TOWN OF EXETER, NEW HAMPSHIRE

**TOWN OF EXETER
PLANNING DEPARTMENT MEMORANDUM**

Re: Definitive Subdivision Submittal for 100 Linden Street
WAIVER REQUEST

Town Planner Comments

Sheet 2 of 10 Existing Conditions

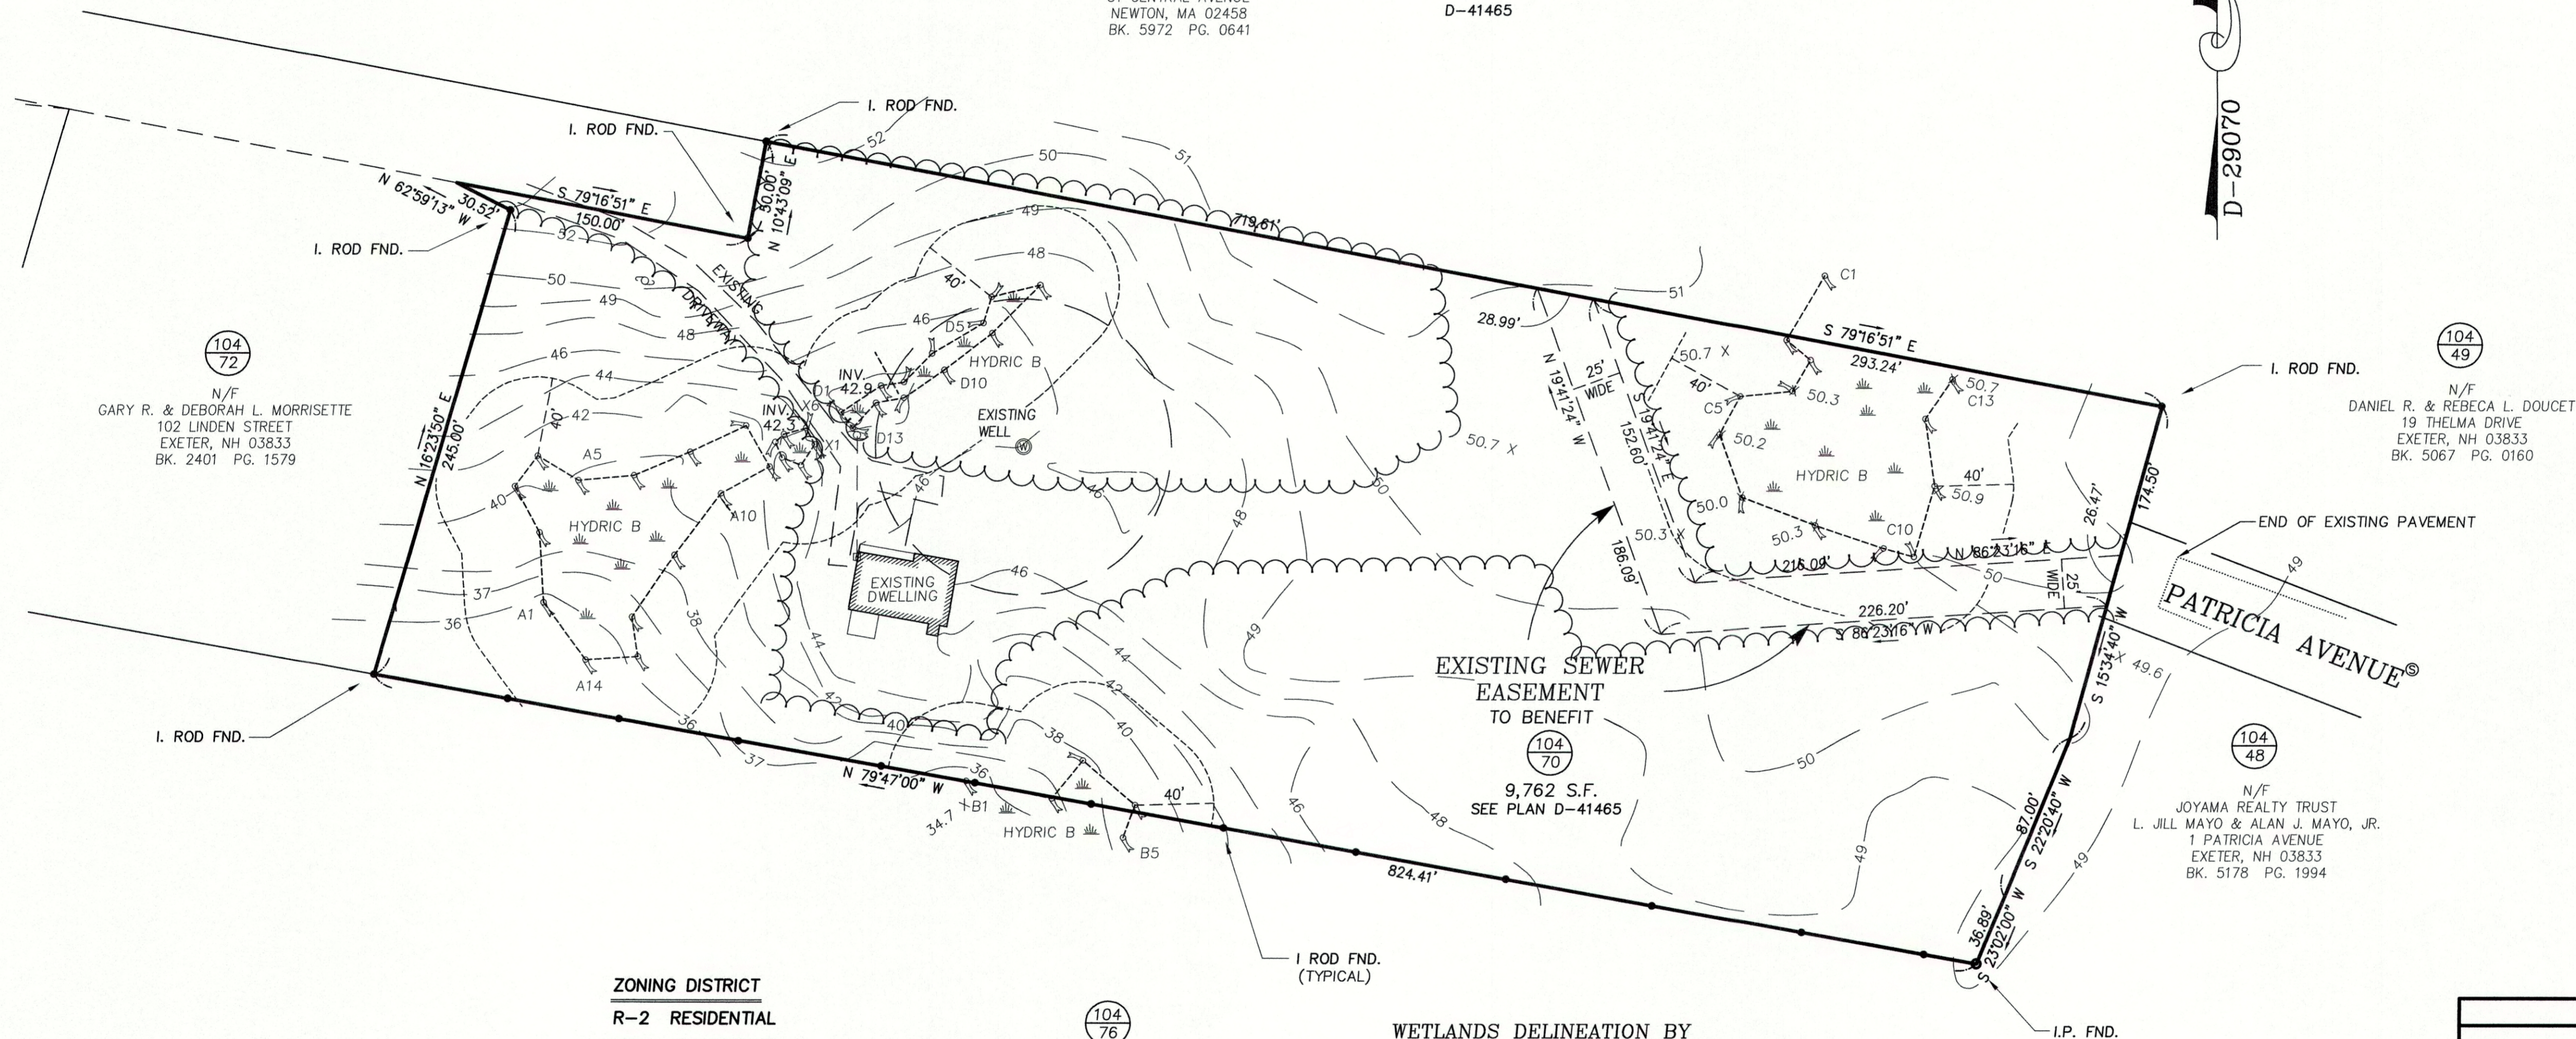
4. *The survey coordinate system should be NH State Plane NAD83. Add note.*

2. **Wetland Scientist:** *The Existing Conditions Plan should be stamped by a wetland scientist certified in the State of New Hampshire.*

3. **Notes 2 and 3:** *Notes 2 and 3 are identical and one of them should be removed from the plans.*

Response: A note has been added to the plan (see note 4).

Response: The final submittal of the plans will include the wetland scientist stamp on the Existing Conditions plan.

Response: Note 3 has been removed.

Sheet 3 of 10 Lot Layout Sheet

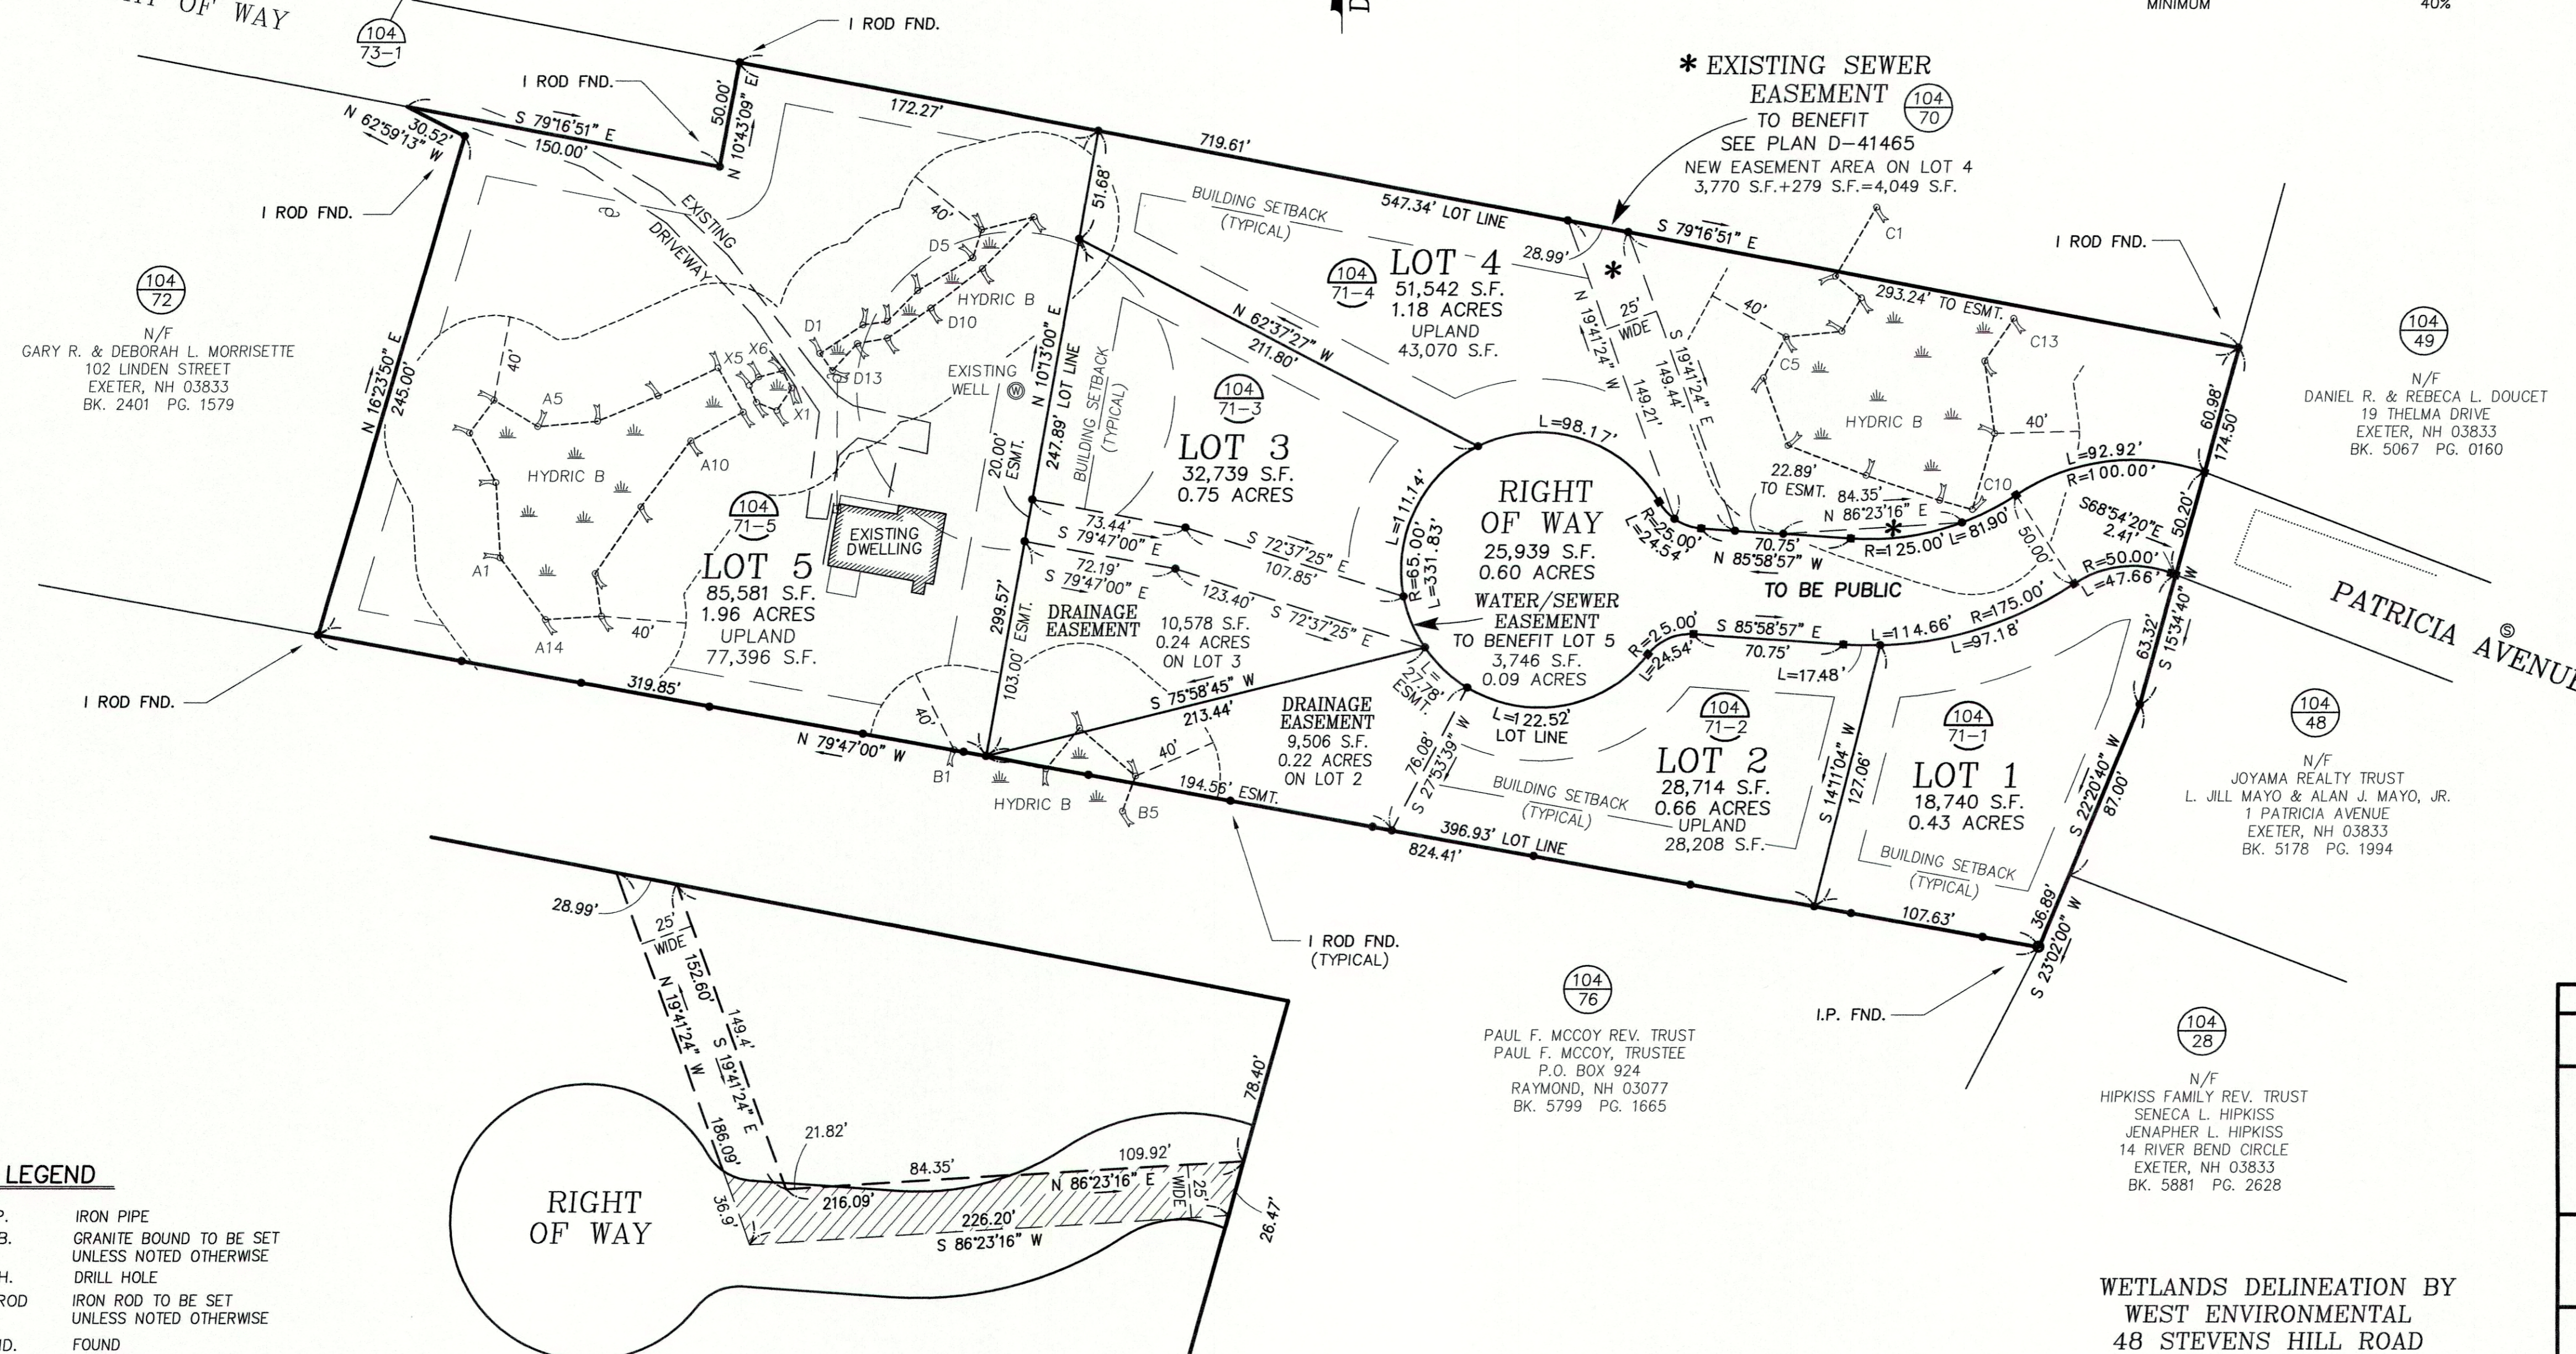
13. *Show the entire sewer easement on Sheet 3 of 10. If approved, does the portion in the public ROW need to be extinguished? What responsibility will the Town have for this sewer line? This needs to all be clear moving forward.*

Response: Sheet 3 has been updated to show the entire easement. The Town will be responsible for that portion of the sewer line within the ROW once it is accepted by the Town.

Sheet 4 of 10 Typical Roadway Sections, Notes, & Details

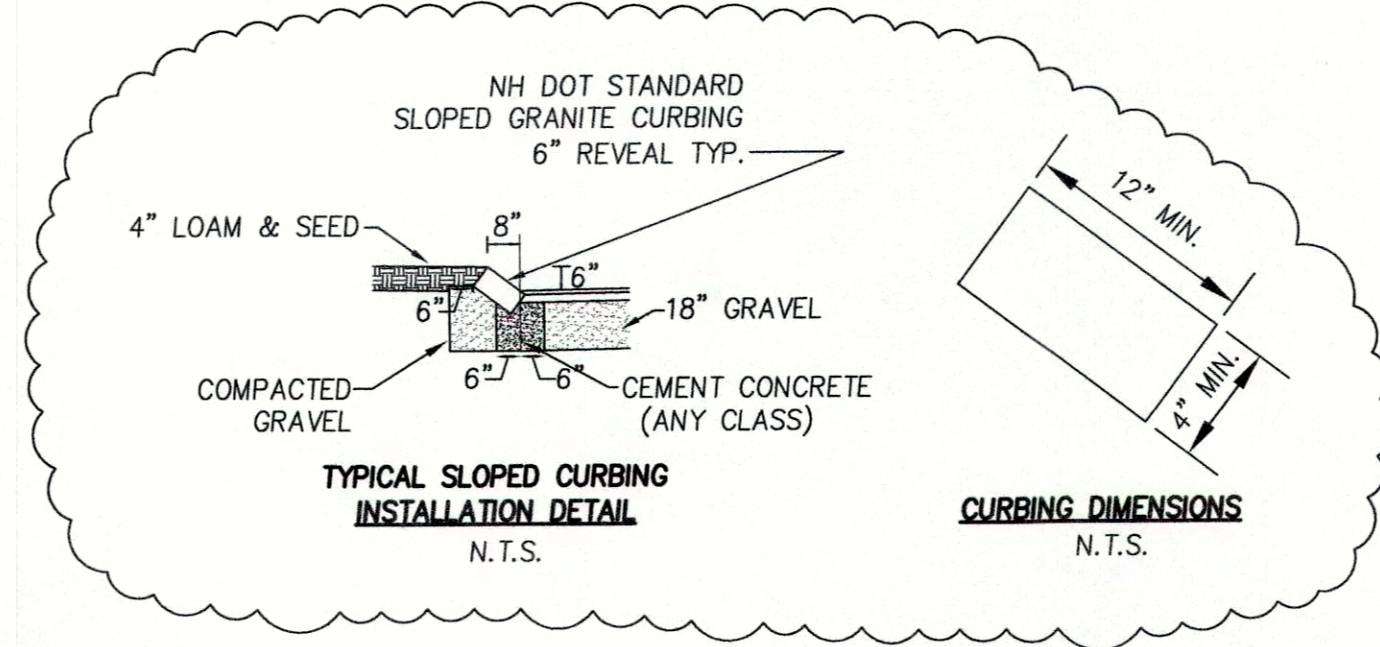
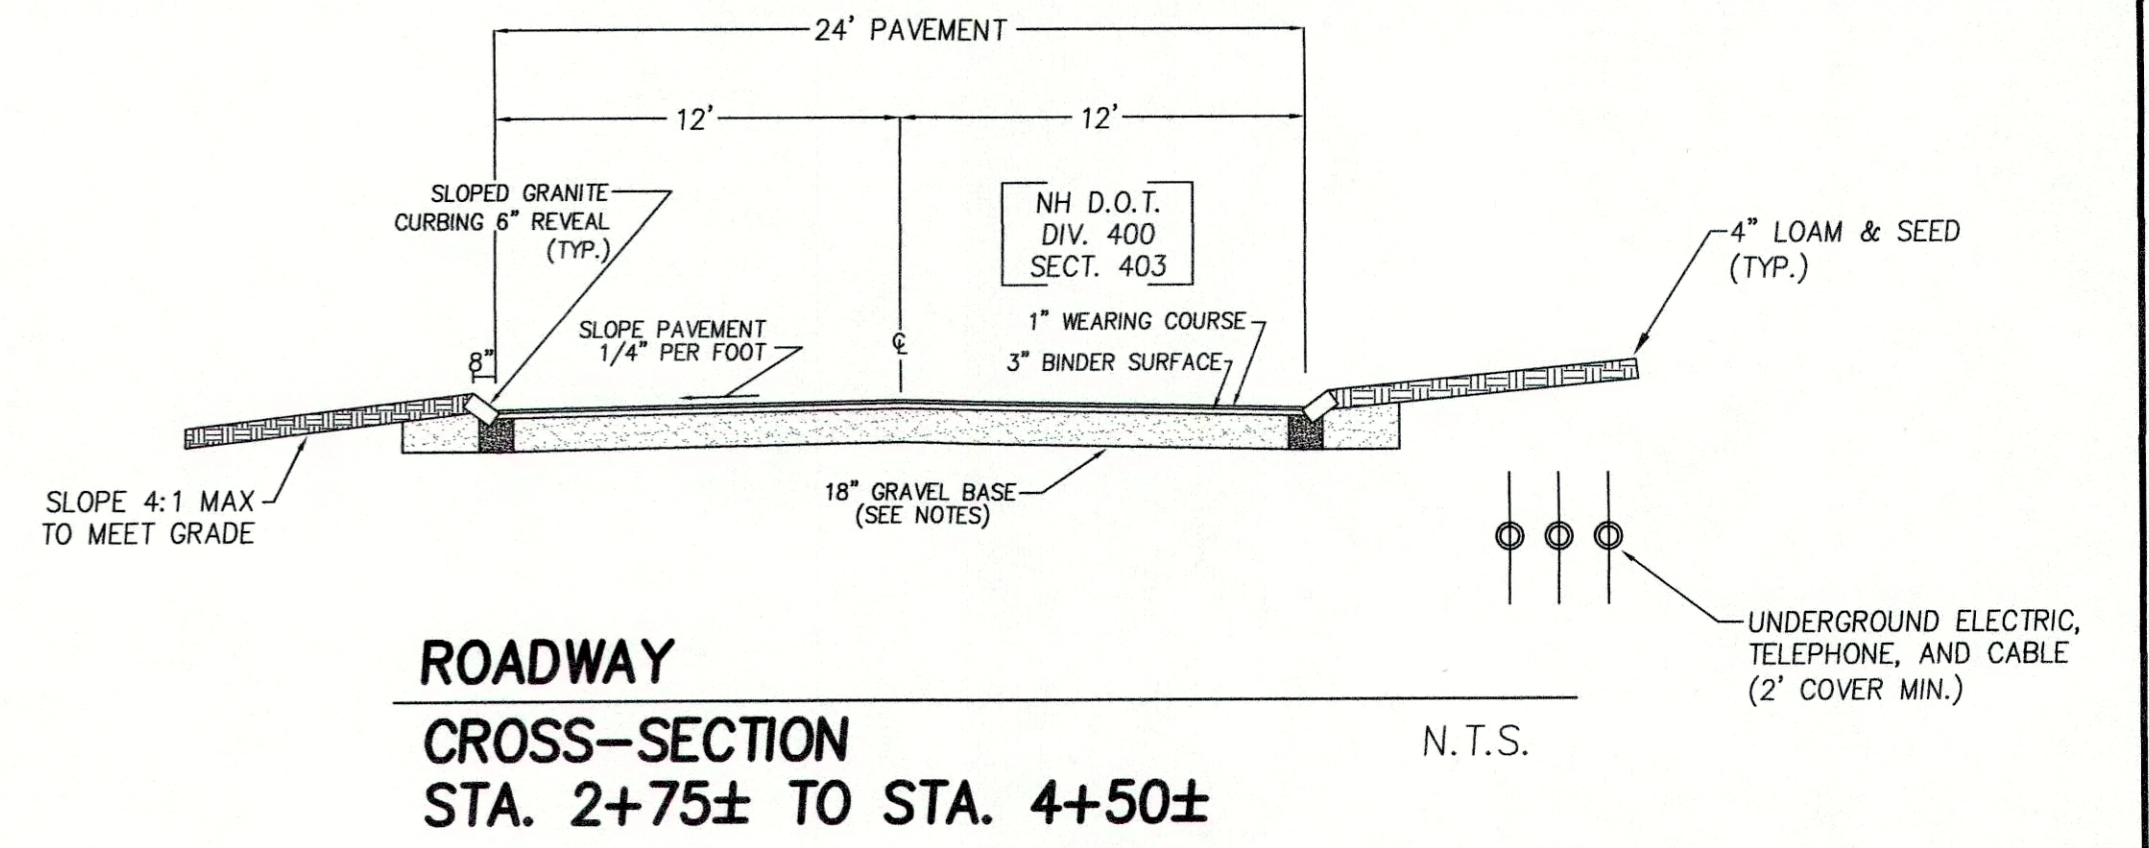
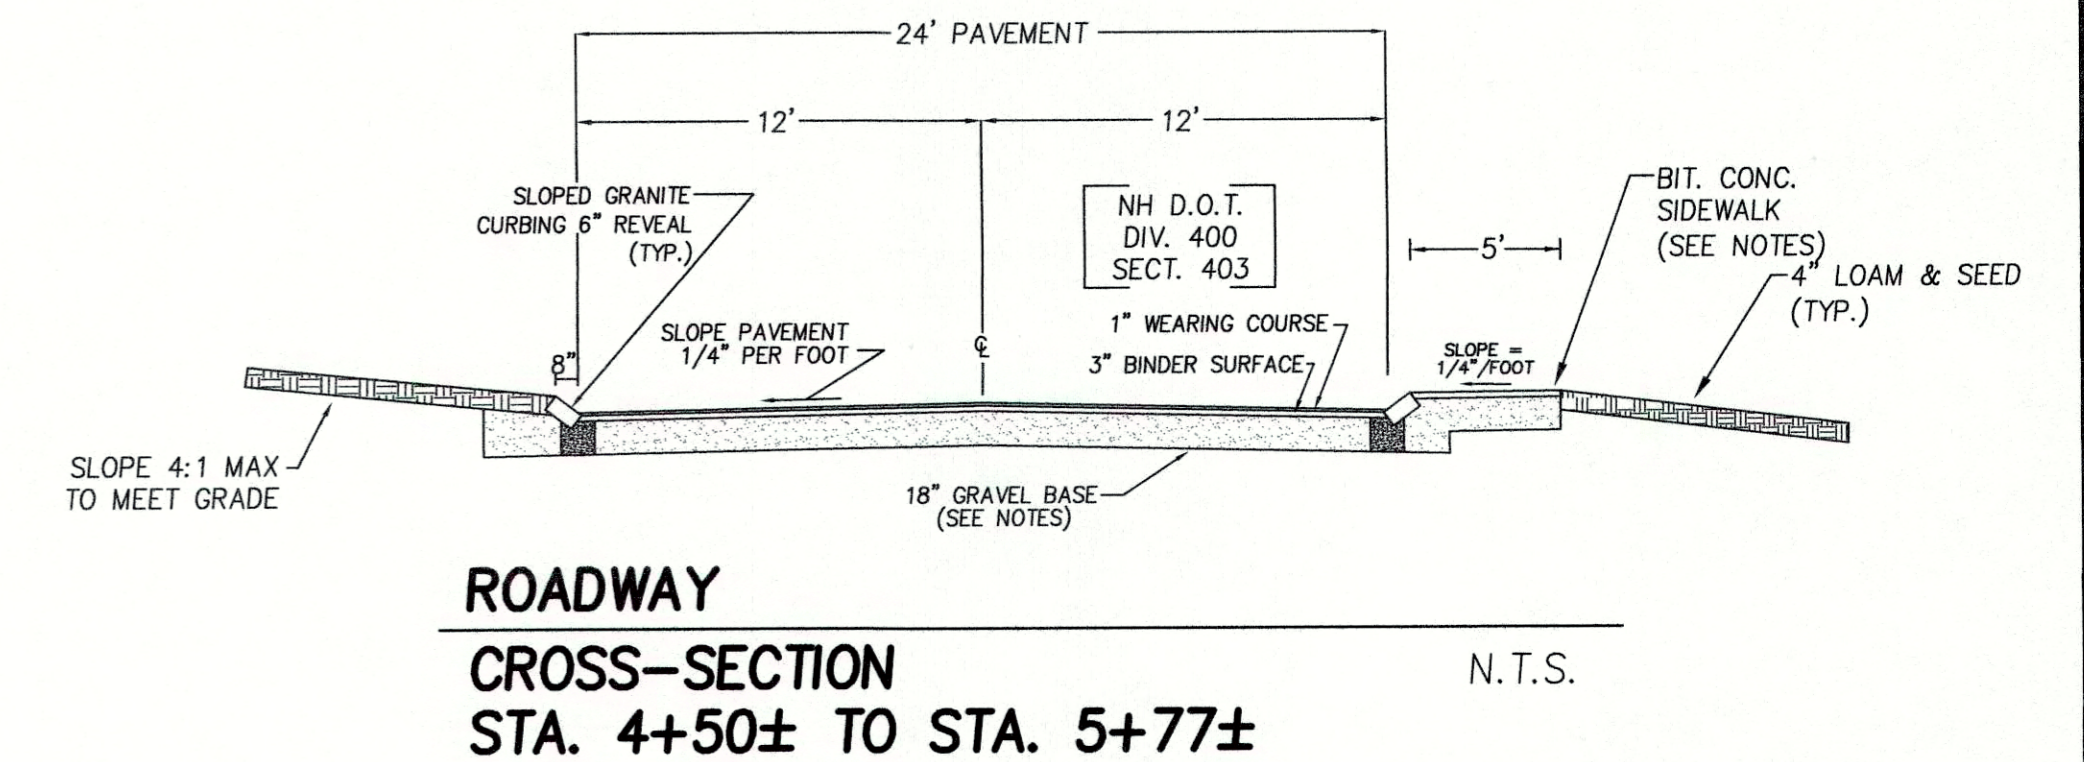
8. *Provide a typical section for the road with and without a sidewalk and identify the station limits for each.*

10. *There is a gas main on the typical section, but none is shown on the plans.*

12. *Patricia Avenue is approximately 28 feet wide. Provide a detail of the transition to the proposed 24-foot wide extension of the road.*

4. **Typical Roadway Cross-Section:** *The following comments pertain to the Typical Roadway Cross-Section detail:*
 - **Gas Utility:** *The cross-section detail shows a gas main as part of the cross-section and a gas main is identified in Note 7. There is no gas main shown on the site plan. Coordination between the site plans and details is needed.*
 - **Underground Utilities:** *The underground utilities (fire alarm, cable, telephone, and electric) are shown to be installed vertically within the same trench. UE recommends horizontal separation between the utilities to facilitate utility repair/maintenance.*

Response: Additional roadway sections have been added to the plan.

Response: There is no gas on Patricia Avenue. All references to gas have been removed from the drawings.

Response: Existing and proposed pavement widths have been added to the plan, along with notes to extend existing edges of pavement (see sheet 6).

Response: There is no gas on Patricia Avenue. All references to gas have been removed from the drawings. Note 7 has been removed. The detail has been revised to show the utilities installed with horizontal separation.
